Covenants Appeal Request Resolution Worksheet

Date. November 20, 2019
Suggested Motion:
"I move to approve to schedule a hearing on in relation to the Covenants Committee's decision to deny the flagstone patio with retaining wall at 3442 Gunston Road".
2 nd :

On July 9, 2019 the Covenants Committee denied the flagstone patio with retaining wall application as the installation does not comply with the current patio specifications and walkway specification.

Covenant Info for Retaining Wall and Flagstone Patio - 72906 - 3442 Gunston

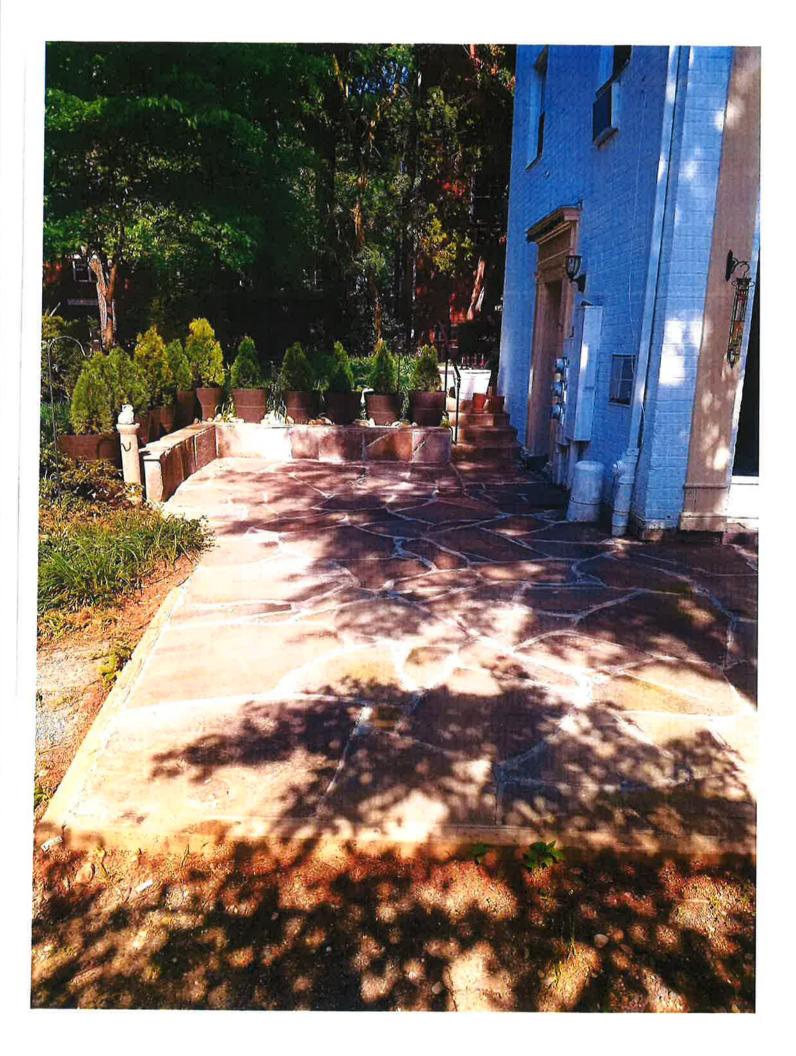
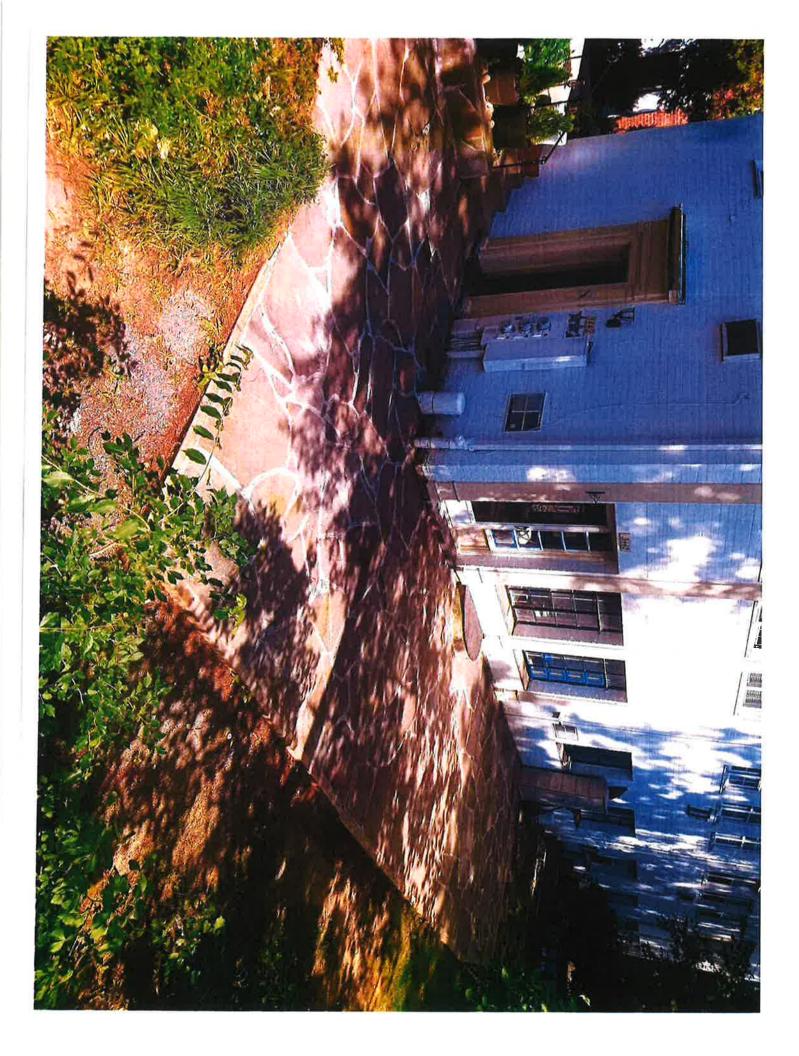
Date: <u>5-31-201</u> 9	Unit Owner: John J. Lisamick
Date:	Unit Owner:
******************	=9070155555555555555555555555555555555555
Action Taken: Approved	Disapproved
Deferred	Acknowledged
Preliminary Approval, subject t	to receipt of City Permit and Inspection
Final Approval, copy of City Per	mit and Inspection received
Stipulations/Reason for Denial: Patio/ with current patio & beyond the lungth of	retaining Wall does not camply Specifications. Patio extends the building
Date: 7 9 19	Signature: Covenants Committee Chair

Retaining Wall: (Parallel to building) 9'5" Length, 1'0" Width, 1'6" Height

(Perpendicular to building) 10'3" Length, 1'0" Width, 1'6" Height

Slope: 3° away from building (see diagram), using standard level
